RE: Tract "A" Southwynd Subdivision Grading and Drainage Plan Engineer's Stamp Date: 08/15/21 Hydrology File: L10D020A

PO Box 1293 Based upon the information provided in your submittal received 09/03/2021, the Grading & Drainage Plan **is not** approved for Grading Permit. The following comments need to be addressed for approval of the above referenced project:

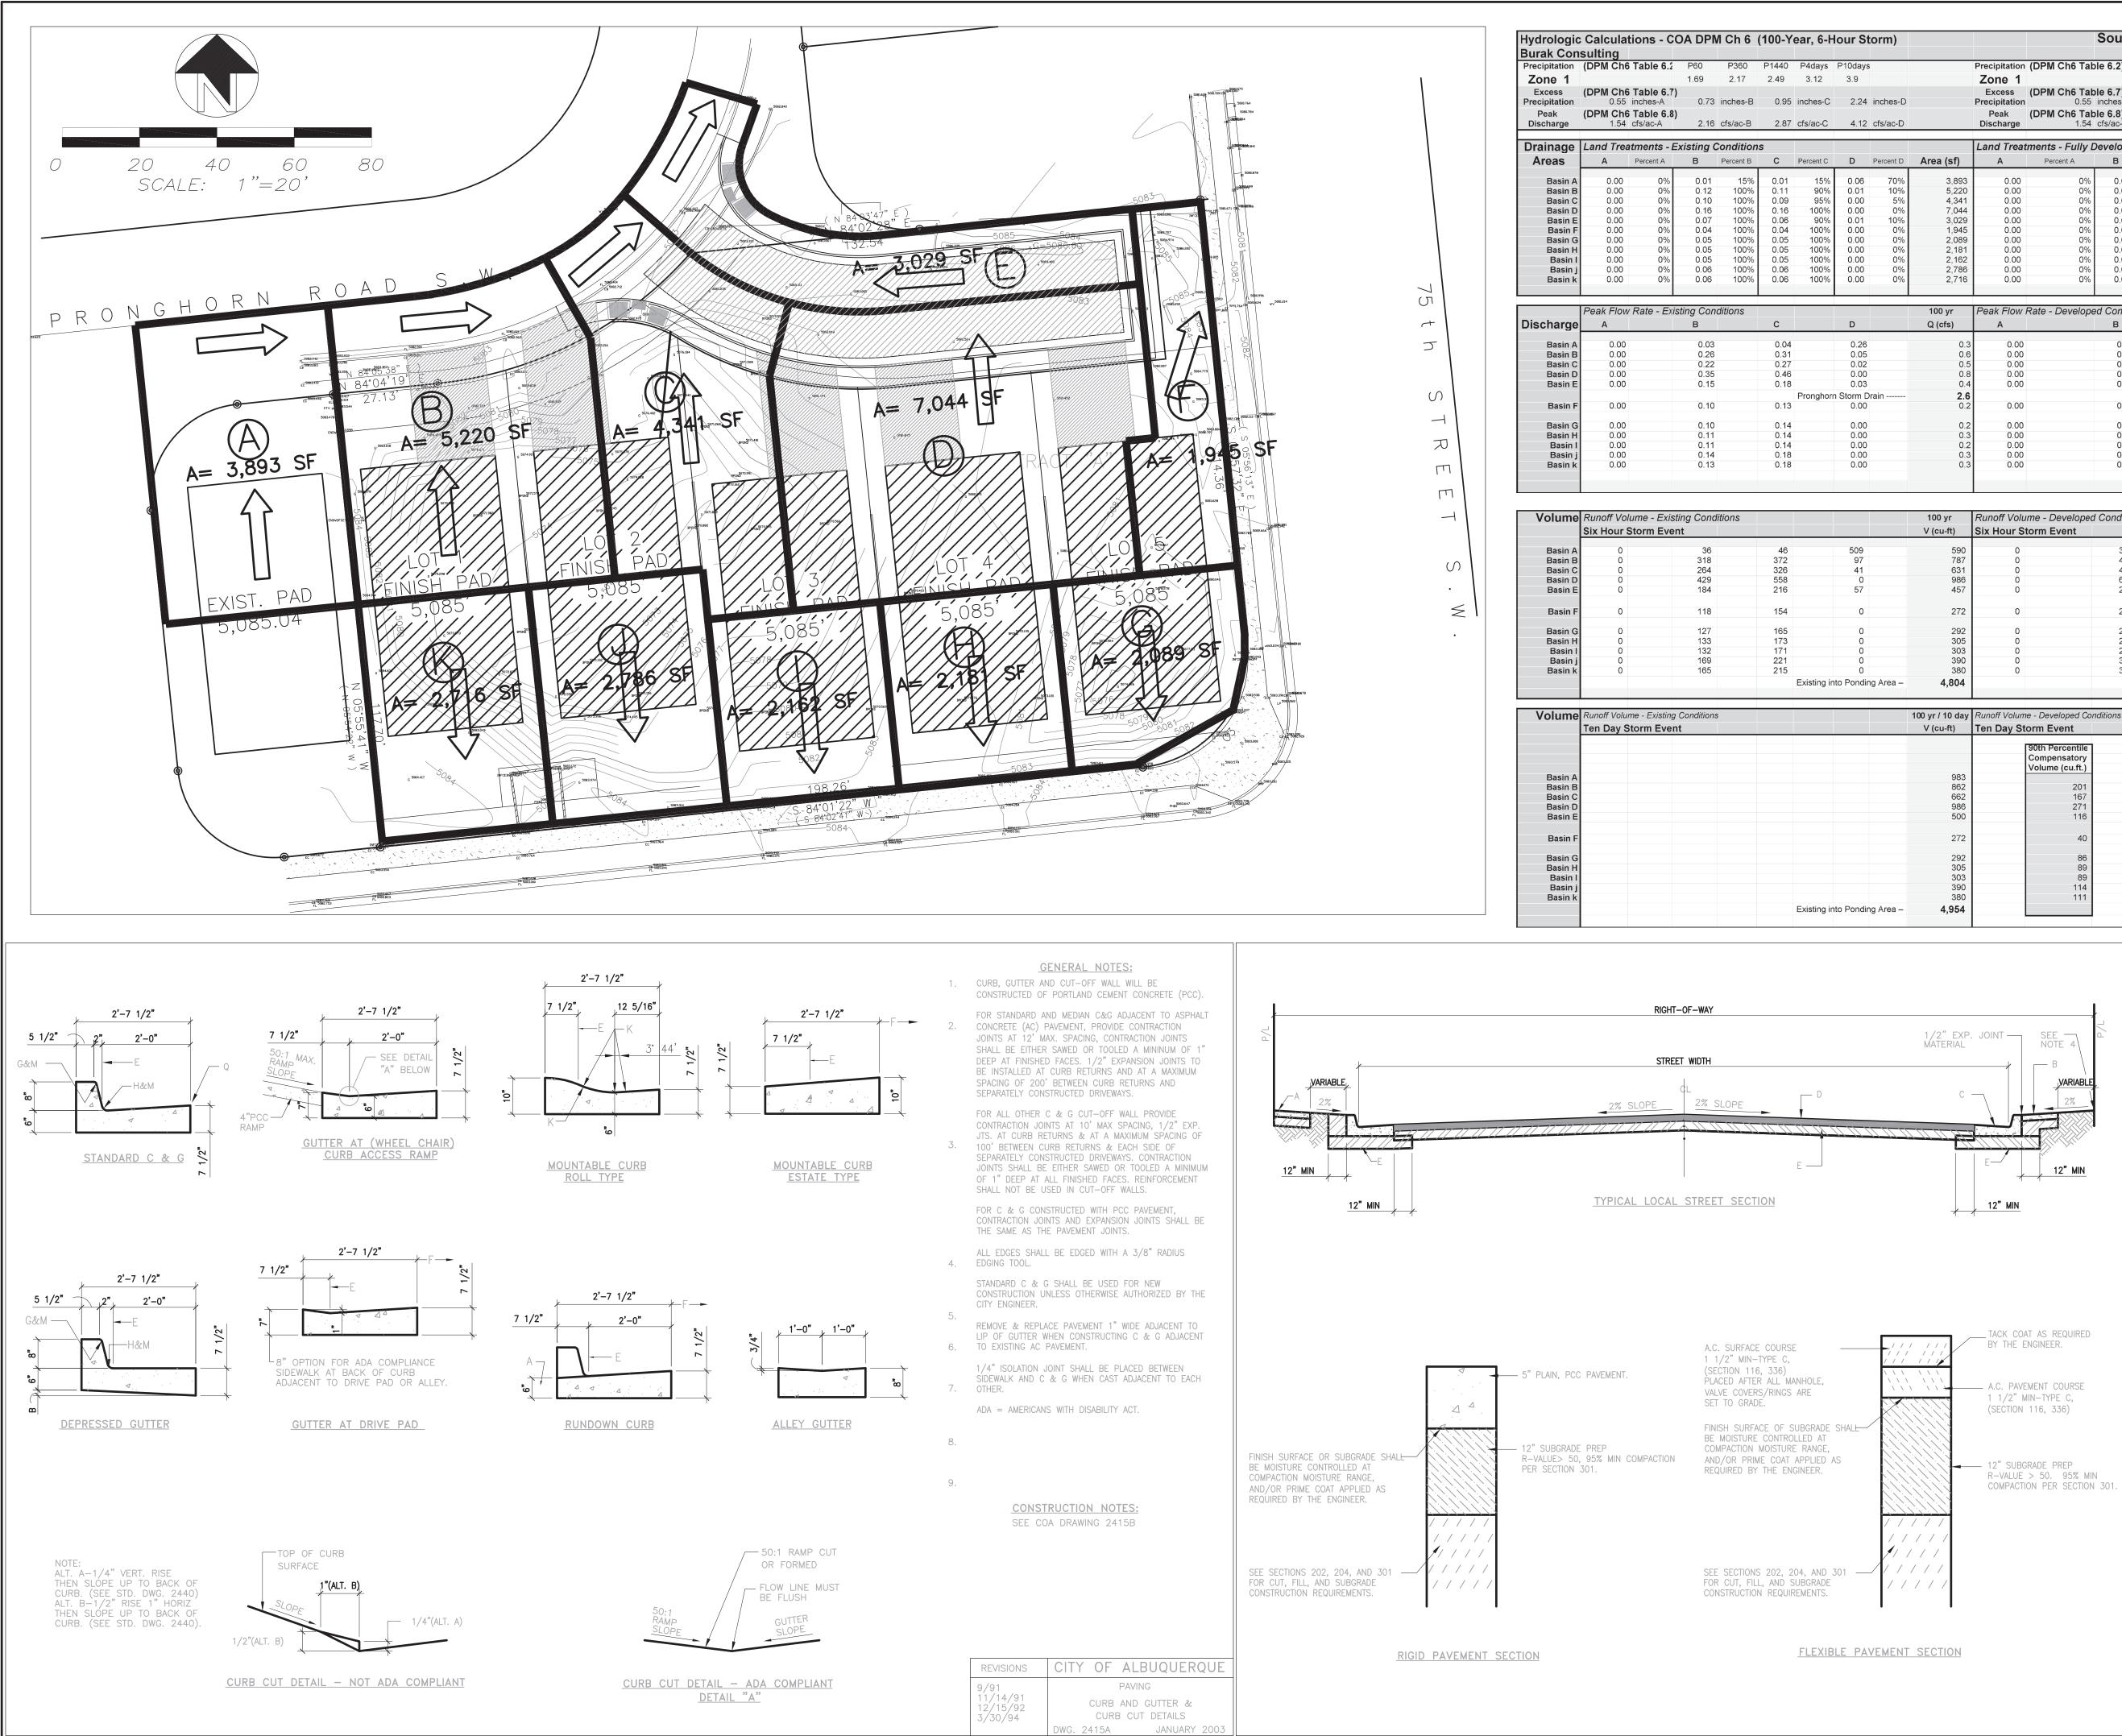
2. Please place the existing floodplain on the Grading Plan.

- This submittal is only for filling in the existing detention pond and creating a gently sloping tract of land from Tower to Pronghorn. So basically the final product for Tract A should then be a general blank piece of property.
- NM 87103

- 3. Since this will be just a simple grading plan, the calculations should be able to fit on one sheet with the grading.
- 4. Standard review fee of \$150 will be required at the time of resubmittal.
